Product Bulletin:

Subject: 24" On Center Logistics Design

Stoughton Trailers is implementing a design change to the plate trailers specified to have the 24" logistics posts configuration. This change will be a running change across both Brodhead and Stoughton dry van plants. Implementation will roll out across the plants over the next few months.

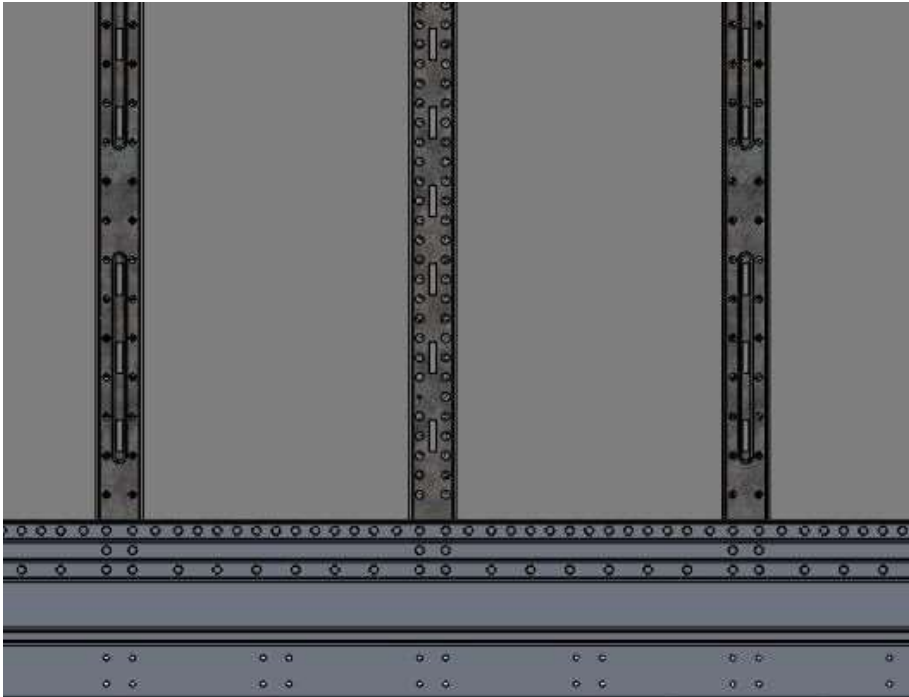
The new 24" on center post design:

- The plates now contain a preformed flute to allow for the inside installation of an intermediate logistics strip. The flute is embossed in the center of a 48" panel.
- The intermediate logistics strips are connected to the panels with rivets on 3" centers (as seen in the RH figure below).
- The redesigned trailer is approximately 50 lbs. lighter than the current model.
